**TOWN OF MATTAPOISETT, MASSACHUSETTS
WATER STREET CULVERT REPLACEMENT**

ADDENDUM NO. 1 – March 17, 2026

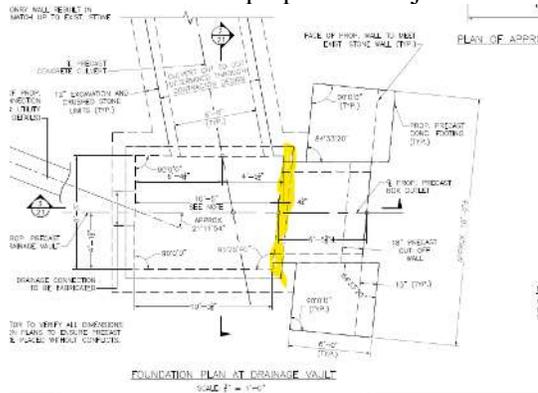
Q2. Can we make this a perpendicular joint or does it have to say on a skew as shown?

A2. The joint between the precast drainage vault and precast box outlet can be perpendicular so long as there is no interference with the proposed precast concrete footing for the replaced section of wharf wall.

**DRAINAGE &
UTILITY PLAN**

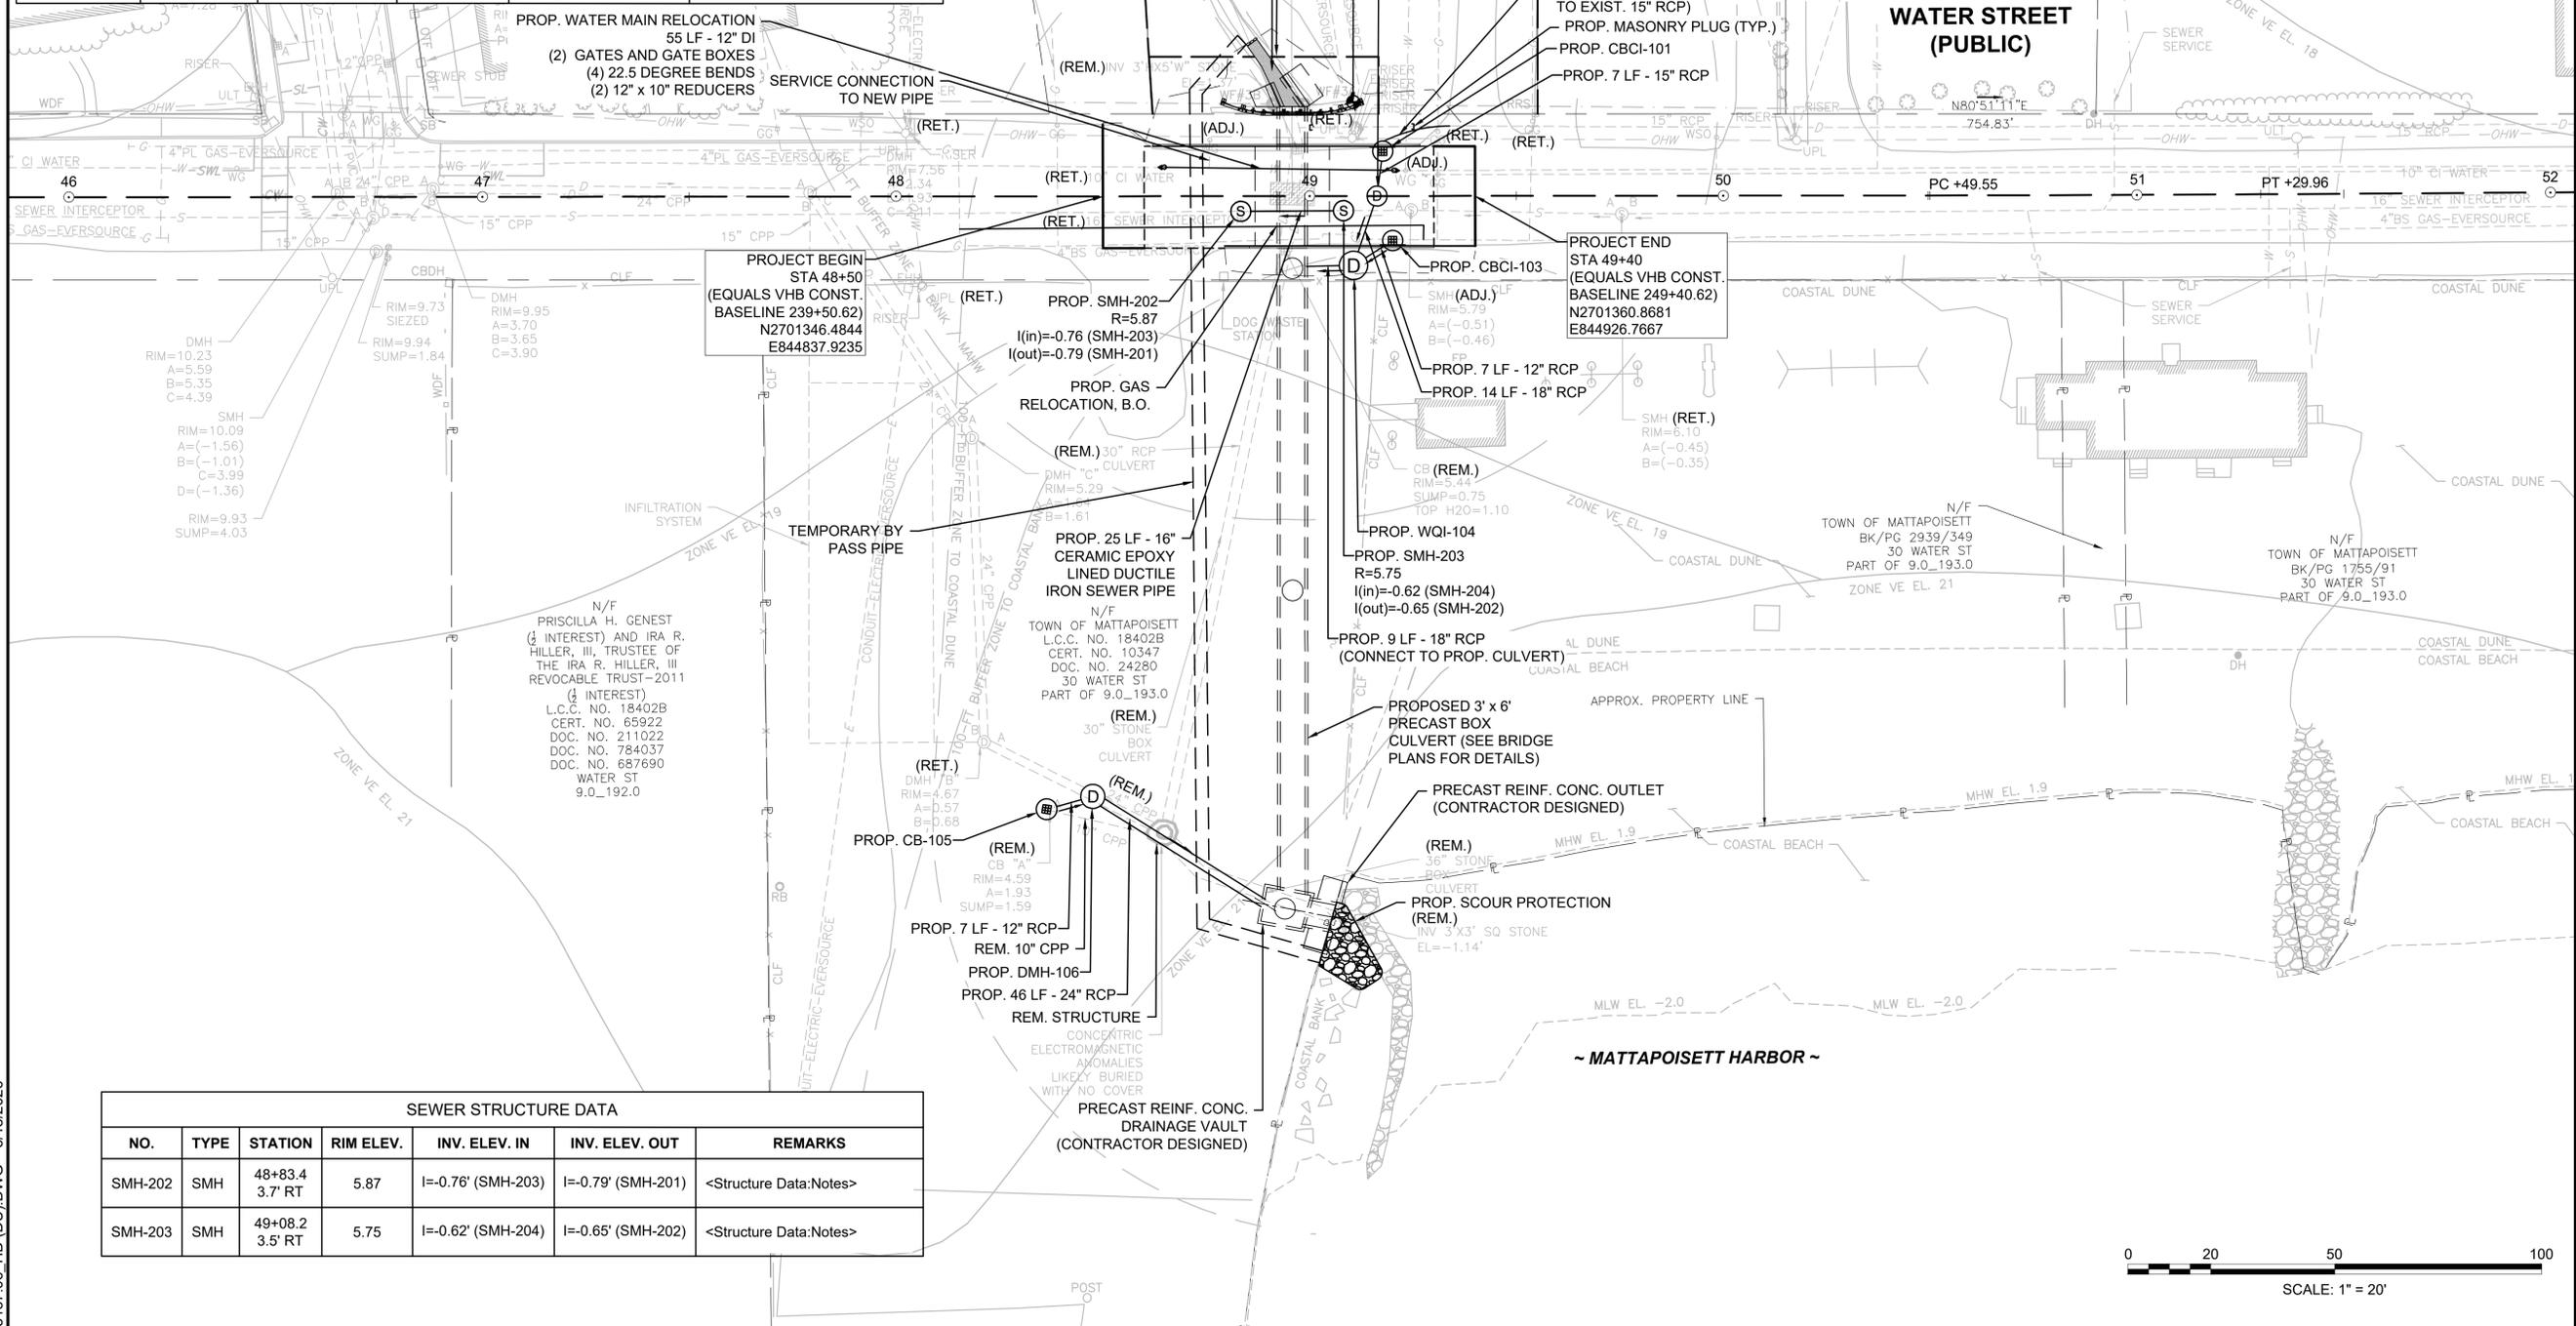
1. Sheet 6, Drainage & Utility Plan (drawing reissued) – The following revisions have been made to Sheet 6, and edits should carry throughout:
 - a. The proposed 10-Inch Water Main has been increased to 12-Inch DI pipe, and the length has been extended within the project limits. The bends have been replaced with 22.5° bends, and 12” x 10” reducers are required on each end. An existing service shall be connected to the new 12-inch main.

- b. Revised Structure Table for DMH-102 under Comments to show – “PROVIDE 21-INCH KNOCKOUT FOR FUTURE 18-INCH PIPE FROM EAST. IN = 1.89”
 - c. DMH-102 in drawing: The DMH is shifted north slightly to center on the baseline. Edit carries throughout plans.

- d. The existing 15” RCP Drain line on the northeast side of project, which is currently connected into the existing box culvert, will need to be terminated as shown. A temporary 15-Inch Corrugated Plastic Pipe shall be installed and connected into CBCI-101. Masonry Plugs shall be provided on each end of the existing 15” RCP to be abandoned.

- e. The Temporary By-Pass pipe has been shifted 10 feet to the west in order to avoid the new Sewer Manhole.
 - f. The northerly access port for the proposed box culvert has been shifted northerly to align with the pipe entering from DMH-104. A third access port has been added to the Proposed Precast Reinforced Concrete Drainage Vault. The middle access port shall be centered between the northerly and southerly access ports.

- g. Replaced DMH-4 with WQI-104 (Water Quality Inlet). Adjusted the lengths of the three pipes into and out of the unit.

PROPOSED TRANSVERSE SECTION
SCALE: 1" = 8'

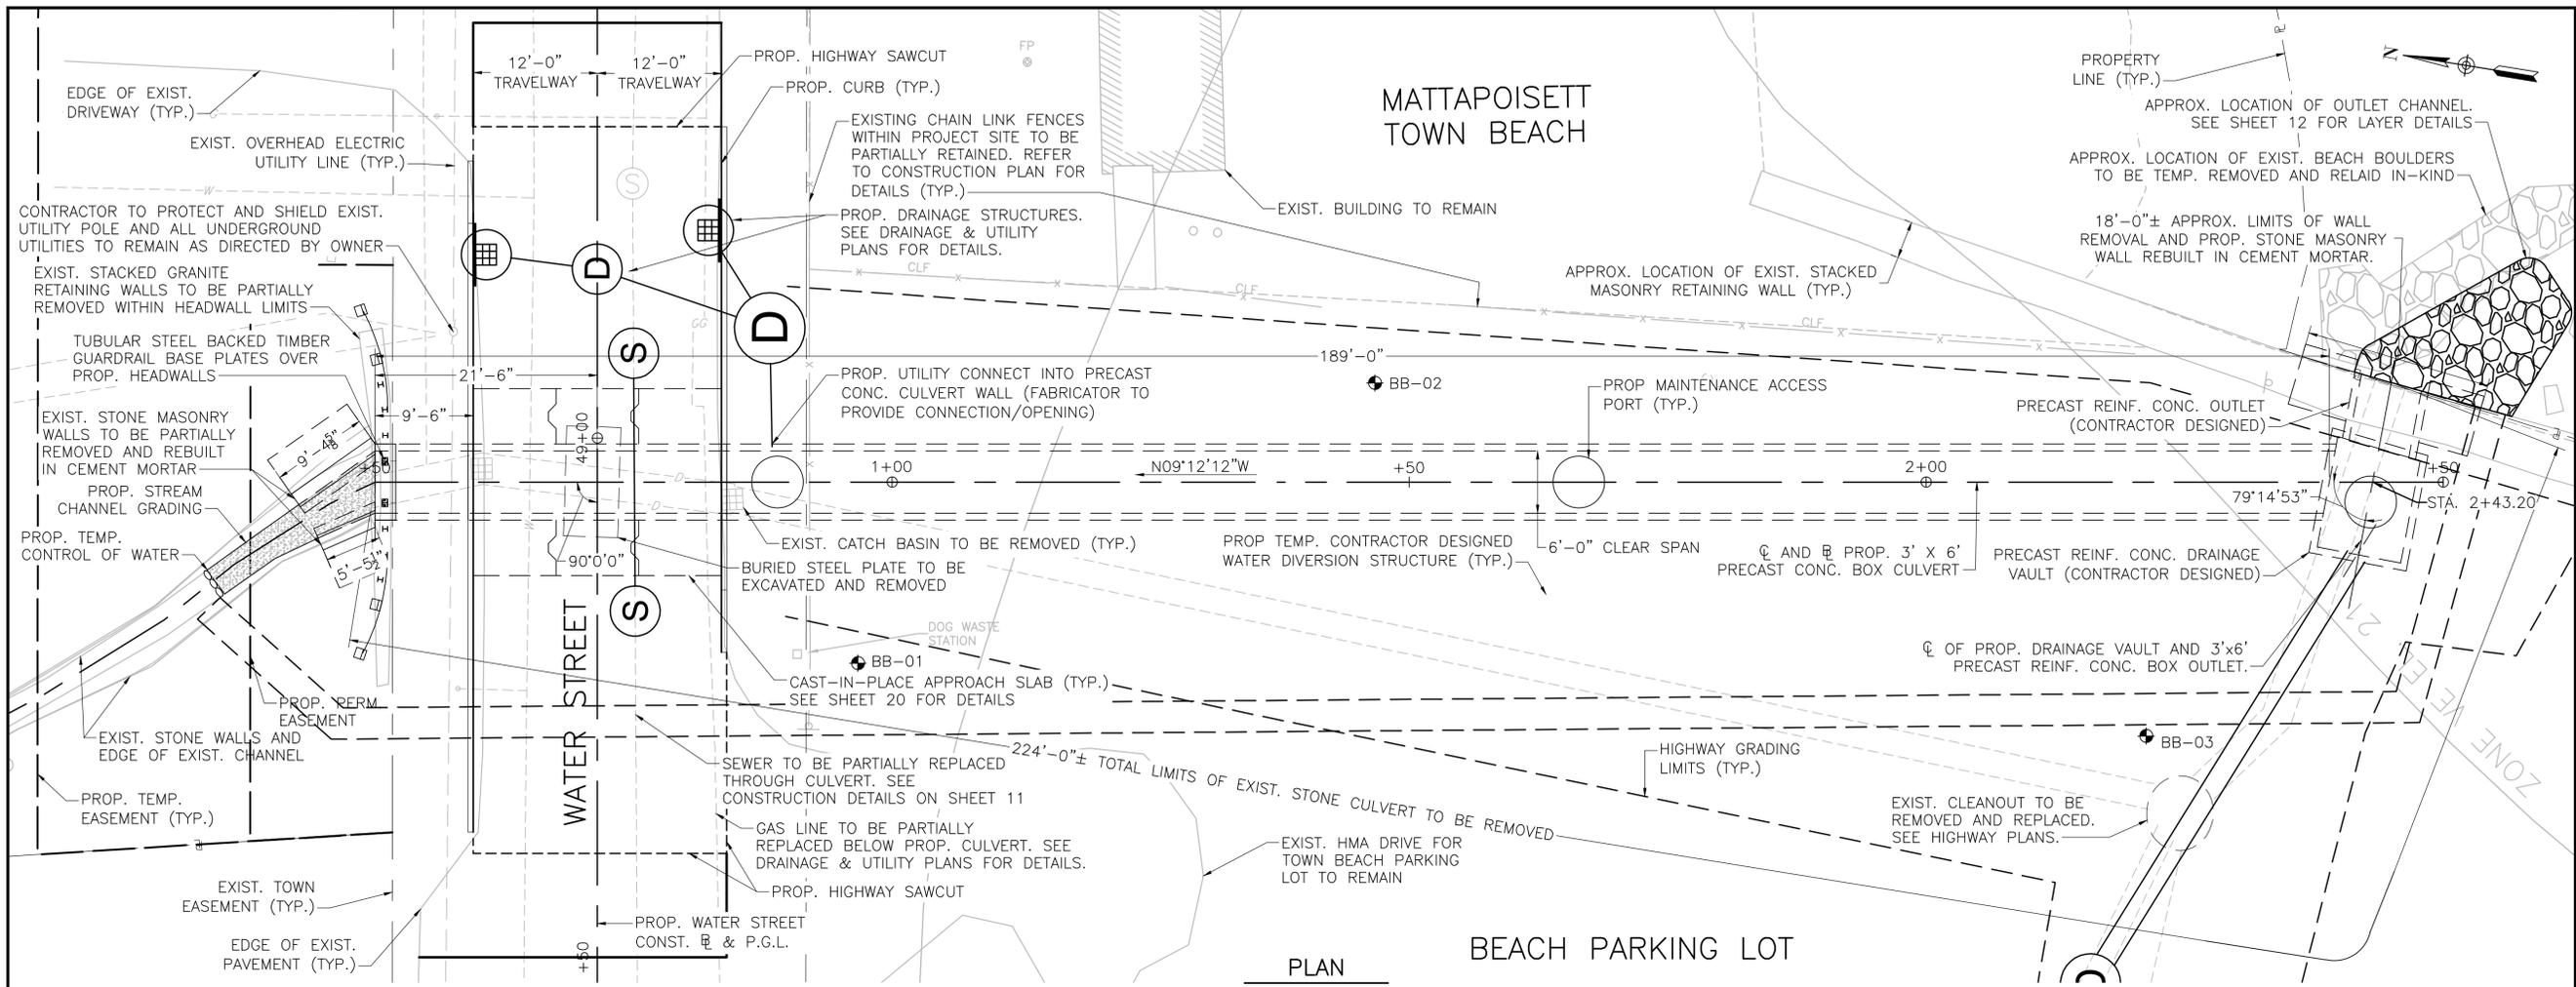
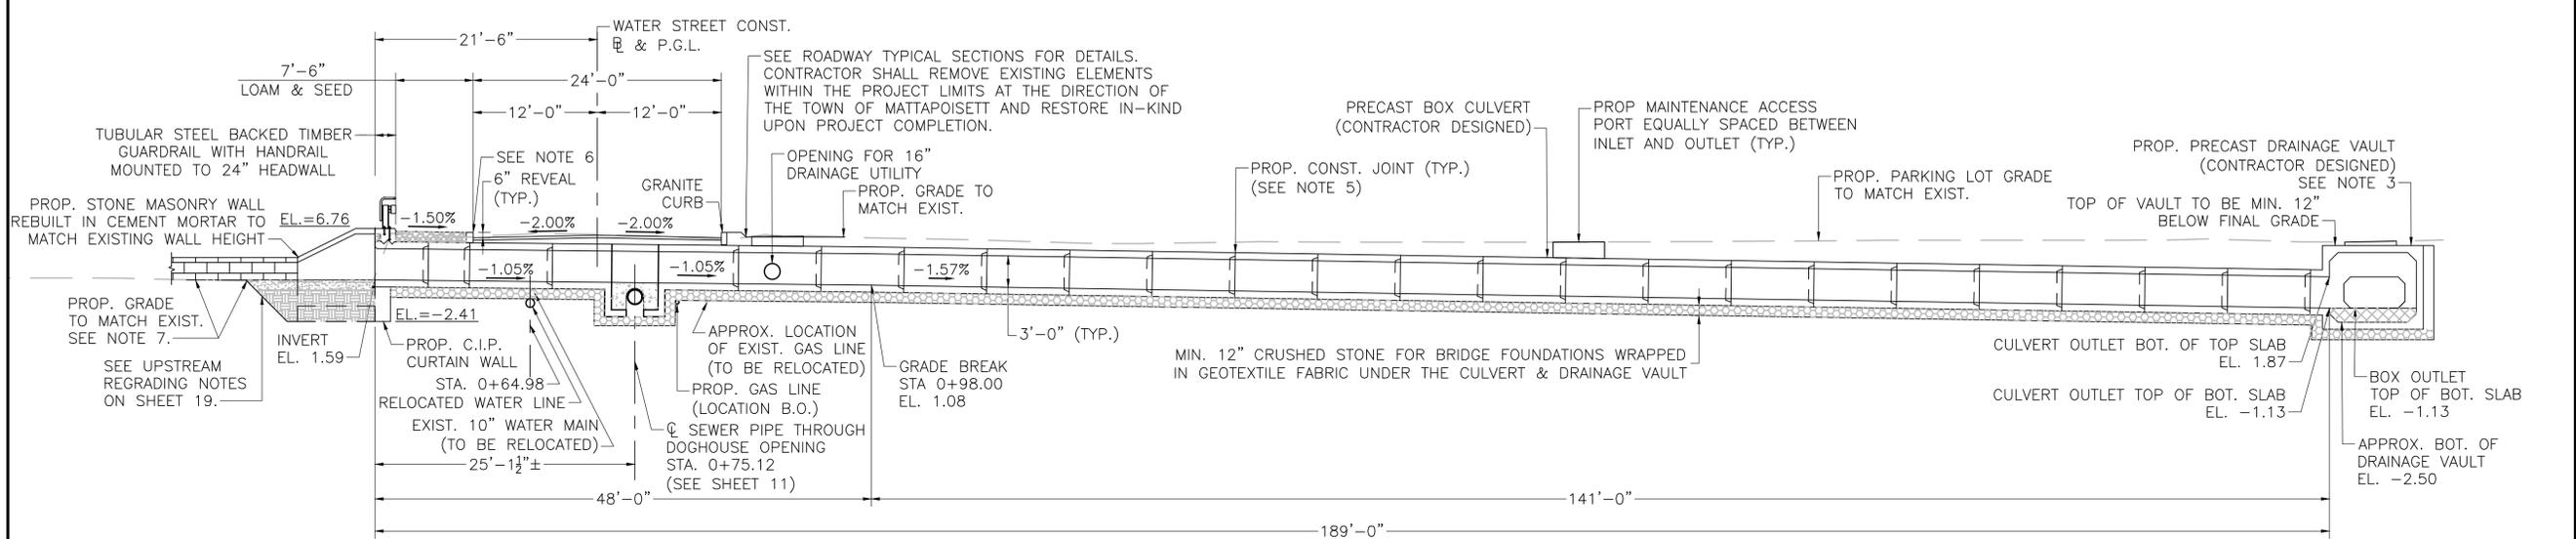
2. Sheet 18, Plan and Transverse Section (drawing reissued) – The following revisions have been made:
 - a. On the Proposed Transverse Section, overlapping text has been cleaned up.
 - b. On the Plan view, the northerly access port for the proposed box culvert has been shifted northerly to align with the pipe entering from DMH-104. A third access port has been added to the Proposed Precast Reinforced Concrete Drainage Vault. The middle access port shall be centered between the northerly and southerly access ports.
